5.1. AMEND APPROVAL AND EXTEND CURRENCY, MCUC 100 MULTIPLE DWELLINGS (TOURIST), A CARETAKER'S RESIDENCE AND ANCILLARY FACILITIES, 97-107 DAVIDSON ST, PT DOUGLAS

REPORT AUTHOR(S)	Jenny Elphinstone, Senior Planning Officer
GENERAL MANAGER	Scott Hahne, A/General Manager Operations
DEPARTMENT	Development Assessment and Coordination
PROPOSAL	Application for a minor change to the approval (conditions) and application to extend the currency period for the Material Change of Use for a Caretaker's Residence, Multiple Dwellings (Tourist) and Ancillary Facilities.
APPLICANT	Laidlaw Holdings Pty Ltd PO Box 2272 Ivanhoe East Vic 3079
LOCATION OF SITE	97-107 Davidson Street, Port Douglas.
PROPERTY	Lots 1 and 2 on RP723702

RECOMMENDATION

Vegetation Management Plan 1

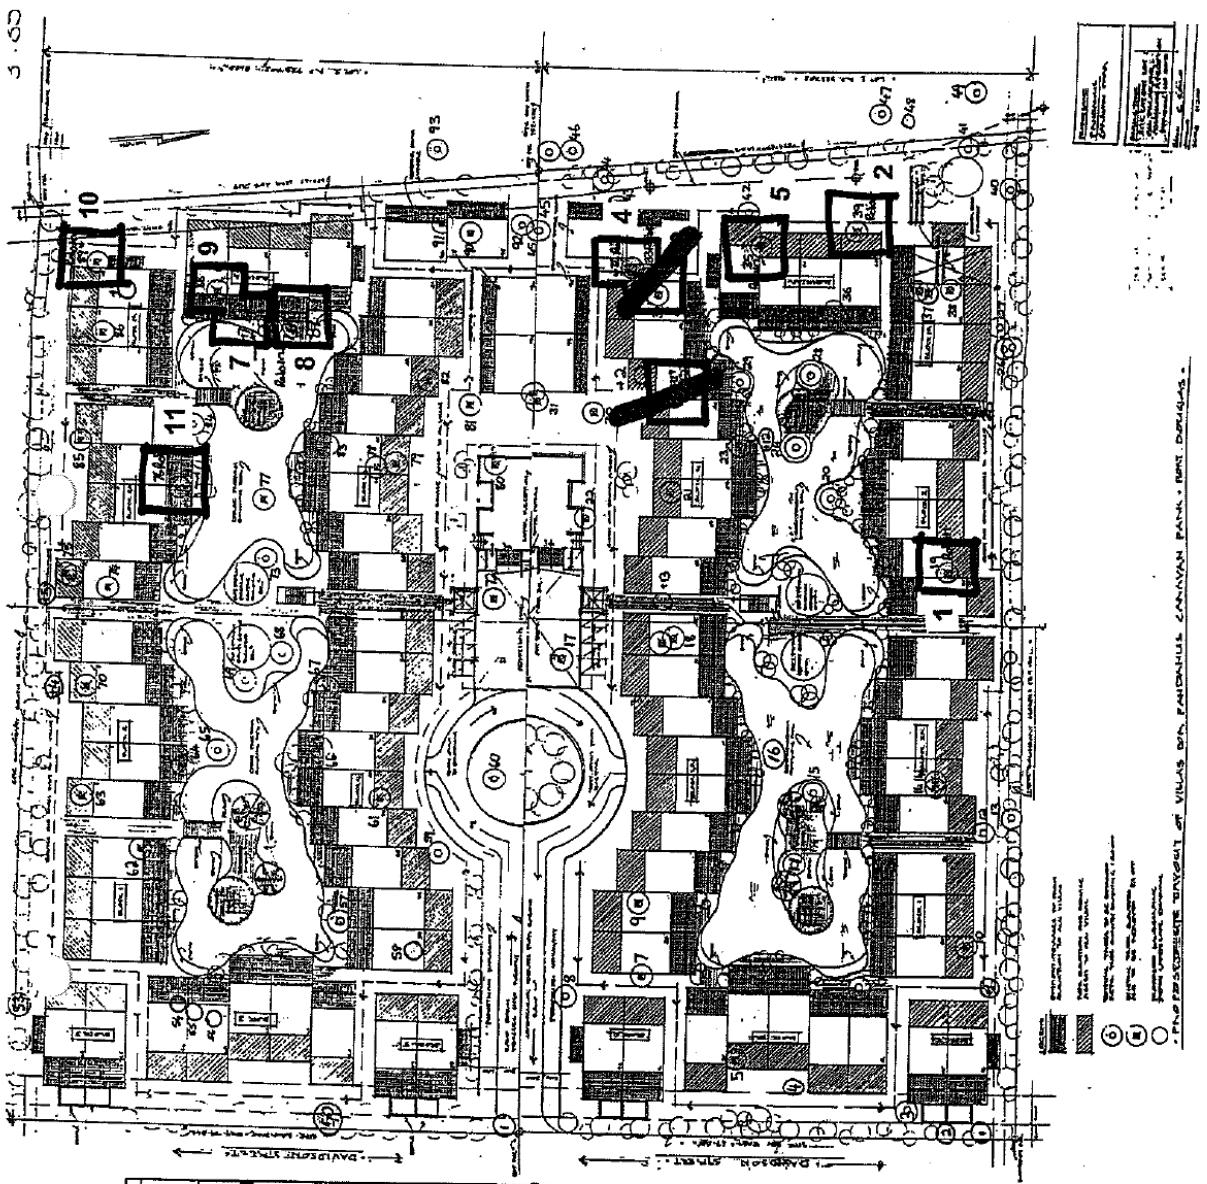
2. The approved plan of development shall be amended as follows:
 - (a) The buildings on the site are to be relocated to avoid the following:
 - i The nine (9) trees marked on the attached plan identified as "Vegetation Management Plan 1". A portion of the developer bond for this development will be held to ensure these trees are retained and managed appropriately; and
 - ii Construction over or within 3.5metres of the existing sewer main within and parallel to the western boundary of the subject site. Alternatively the applicant is to provide an engineering solution to the satisfaction of the Manager Engineering Services. Any alternative solution is to be prepared and certified by a registered structural engineer.

3. The landscaping plan submitted with the proposed development and prepared by Pawsey & Prowse has been approved, as part of this development, subject to the following amendments:
 - (a) Davidson Street planting bed is not to include *Syzygium jambos*. Native *Syzygium* species are to be used in their place.
 - (b) The nine (9) trees marked on the attached plan identified as "Vegetation Management Plan 1"
